ST ANNE'S QUARTER, NORWICH

SECTION 73 - DESIGN AND ACCESS STATEMENT
DECEMBER 2016

SECTION 73 APPLICATION CHANGES

ST ANNE'S QUARTER, NORWICH SECTION 73 DESIGN AND ACCESS STATEMENT

Figure 6 - IW proposed revised massing to blocks D1 & D2

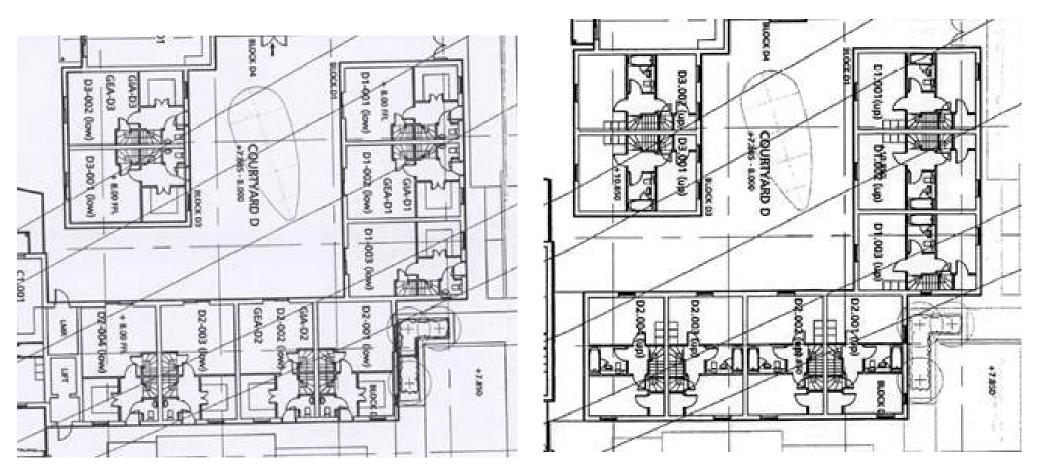
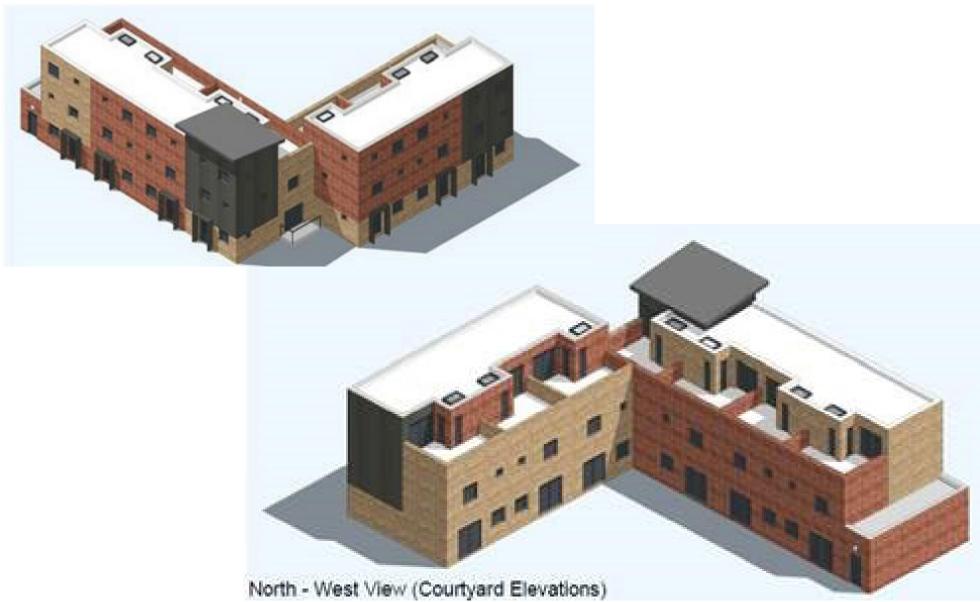
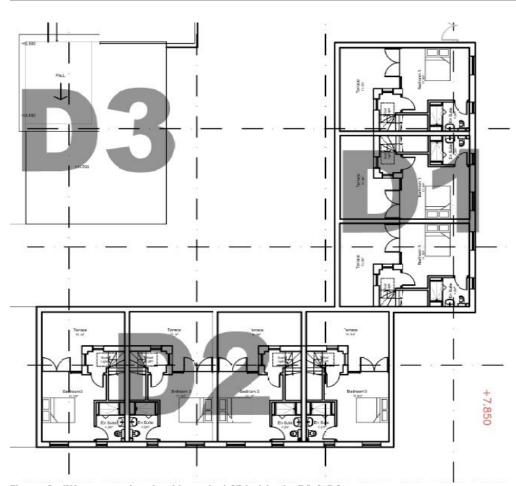
The proposed IW design seeks to amend the design of these units to both increase their commercial appeal and to enhance the design of the units themselves.

It is proposed that whilst the ground and first floor remain substantively as approved, an additional storey be added over half of the floor plate at second floor level. This provides a more viable and attractive townhouse with an additional amenity terrace at second floor level up and above podium deck.

The elevations to both public realm and private areas have been amended to better reflect the fenestration of the remainder of the site and material composition also adjusted to match.

Figure 19 - Revise layout to bock E1 featuring proposed manaement suite and new apartments relocated from G2/G3

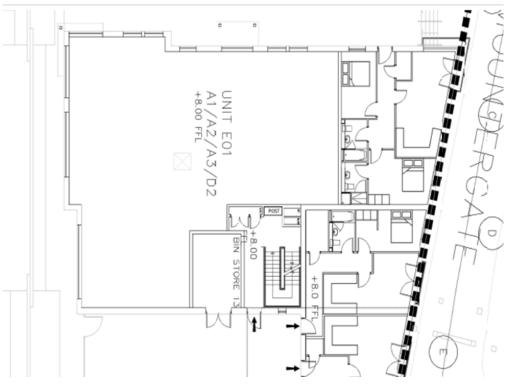
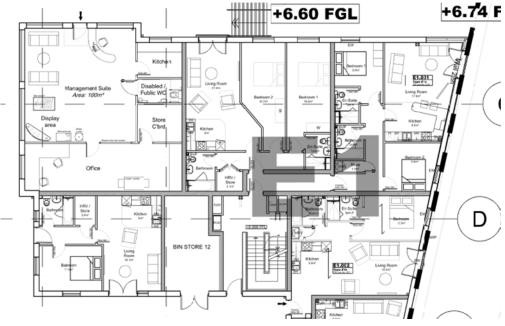
It is the intention of Orbit Homes that they will place their own site management suite within the commercial space within E1. This unit will act as the on site hub and contact point for all residents. Initial discussions with OH have indicated that the maximum size required for this facility is 100m2.

The remaining space, formerly part of the commercial space within Block E1 will be converted to residential apartment use with the inclusion of 1x 1 bedroom apartment and 1x 2 bedroom apartment.

This will result in a small change to the external envelope of the block including the elevation facing Howard House, as included on the submitted elevational drawings but this change is not regarded as of significance albeit in the context of an important listed building.

It is also highlighted that steps used to provide external access to one of the upper lever apartments between Howard house and block E1, has been removed. Internal replanning of block E1 has allowed access to all units to be provided via the common entrance to this block. The removal of the stairs provides greater clarity of the path route between E1 and Howard House.

Figure 24 - Proposed revised treatment to elevational design of F1

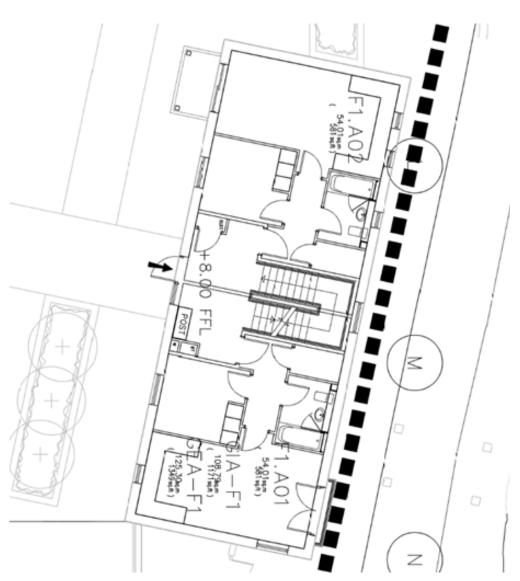
On discussion with both the client and planning authority it has been identified that block F1 required review to enhance the design of the block as it forms a key part of the mountergate elevation.

The design of this block of single bed apartments has been reviewed and new proposals submitted with the application.

The aim of the revised approach has been to enhance the overall design and make this more attractive, recognising that this is a key block on the Mountergate elevation. In addition, the generally reconfigured windows to Mountergate enhance daylight into units.

Figure 27 - IW proposed layout featuring Juliet balconies to upper levels where facing residential aspects of Baltic Wharf

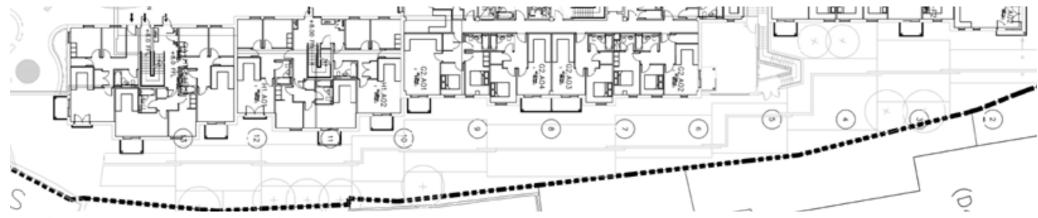
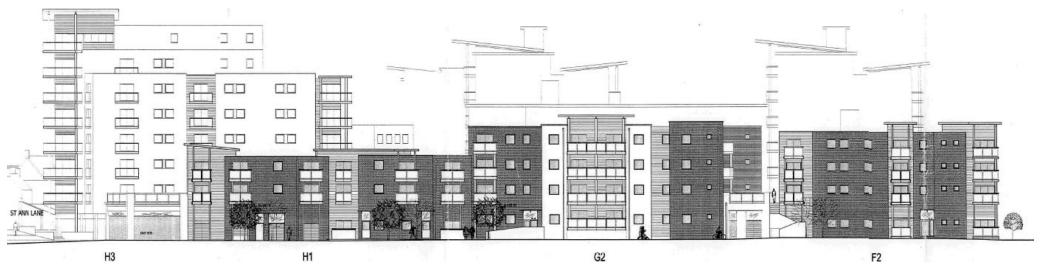
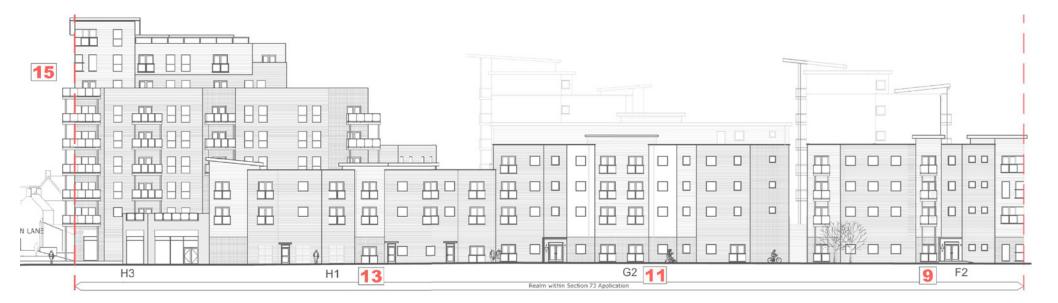
In order to address issues raised during discussions with planners and adajacent landowners, it is proposed that the projecting balconies featured on the Benoy scheme, to the substantive part of East Street, be replaced wholly with Juliette balconies. Previously balconies projected approximately 1200mm from the building principal frontage and now are retracted to within approximately 75mm of the building face.

Whilst is to the detriment of the amenity of the apartments, the retraction of the balconies assists in ensuring that balconies are clear of the tracked path of vehicles using East Street. In addition, this gives a further reinforced distance between the new dwellings and the residents of Baltic Wharf. The changes shown in relation to the East street frontage are specifically shown on drawing 31359-IW-ALL-UG-M2-A-11004 – East Street Balcony Comparison.

Figure 30 - Extract of detailed design drawing of smaple panel to be constructed on site for review

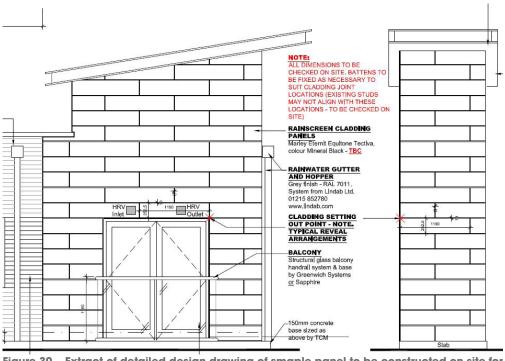
The Benoy approved scheme extensively features the use of timber boarding as one of the components of the materials palette. On review of the approved scheme, reservations have been raised by the client and design team about the use of natural timber as a material on the scheme in relation to it's longevity and cosmetic appearance as the material weathers. Examples of the use of timber in Norwich are commonplace and in the substantive part are not regarded as a positive contribution the urban environment as many have matured to a dark grey brown colour and are often subject to extensive staining etc..

It is proposed that Marley Eternit Tectiva (colour 'pebble'), a cementitious through coloured board be used in place of the timber boarding on areas within this section 73 amendment and other areas to be considered in later applications.

A full sized sample panel of materials is to be constructed on site in order that the nature of the material can be fully appreciated and understood prior to anticipated approval of the material.

Figure 37 - Revised IW H3 Level 5 layout with 2 premium apartments facing east

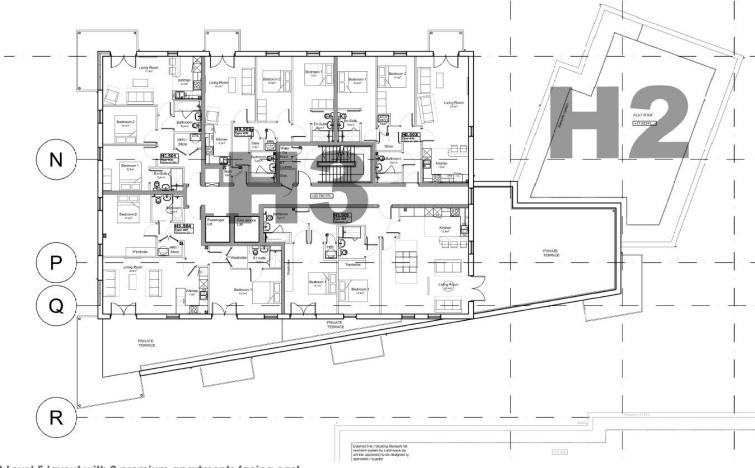
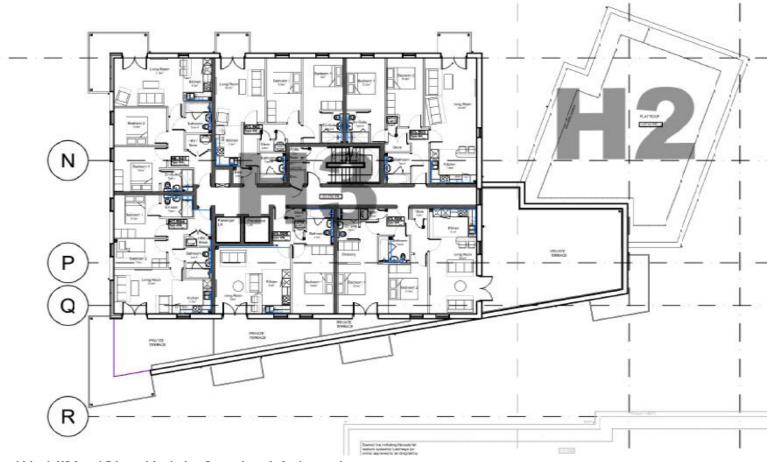
At level 5 of H3 the apartment layout varies where there is opportunity for superior apartments with enhanced size roof terraces. On this level the opportunity has been taken also to merge 3 small apartments (56.4m2 ,51m2 and 73m2) into 2 large and more marketable apartments better suited to this elevated position (82.5m2 and 98.6m2)

Figure 47 - IW proposed Levels 6 and 7 apartment layouts

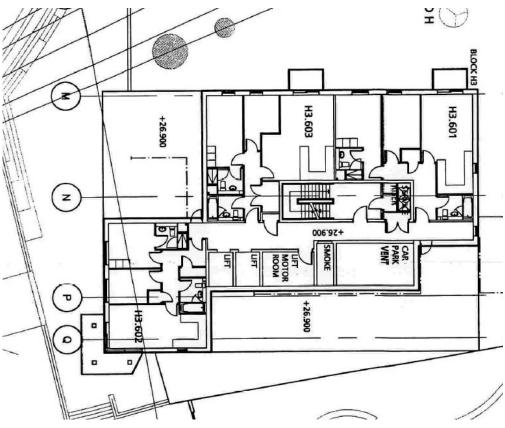
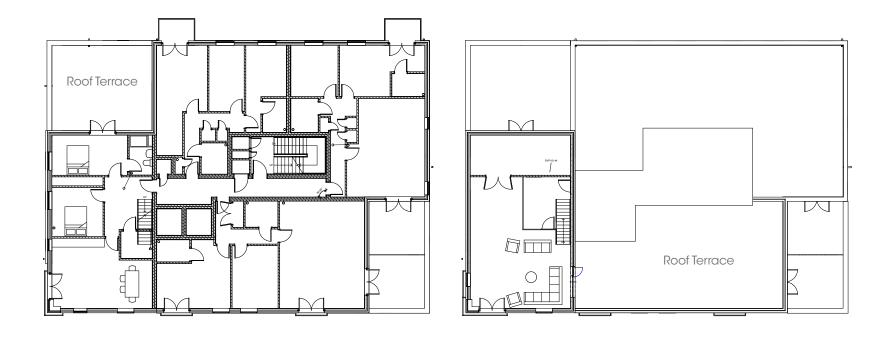
The clustering of building mass on the uppermost floor where plant rooms were accommodated is poor and allows no advantage to be taken from this orientation and river view.

The design team have carried out a reviews of the proposed plans and massing of H3. Early in our process we identified that the plan of the building featured a large air vent shaft associated with the car park at lower ground floor level. This both occupied valuable residential footprint and at the top most level added a blank box to the building mass. By re-designing the floor plate layouts and the removal of the air shaft and relocation at deck level, this has relieved pressure on the tower apartment layouts and removed awkwardly designed building mass at top level. The removal of the shaft and other superfluous plant space has allowed us to enhance residential space at these upper levels. This also allows us to take greater advantage of the east façade gaining city and river views.

Figure 50 - IW proposed roof level view with new terraces = red rectangles denote terraces

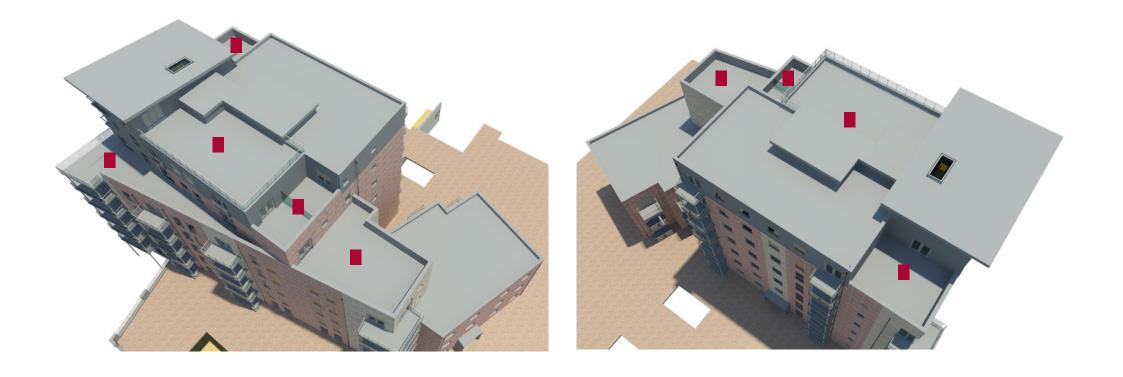
In regard to maximising the design and liveability potential of block H3, a review was undertaken on the provision of external space available to individual apartments. It was

felt that with the rationalisation and re-sculpting of H3, significant opportunities were available to better this situation. New enlarged terraces have been gained at levels 5-7 of the scheme, enhancing the appeal of the apartments whilst having negligible effect on the amenity of other residents of the site.
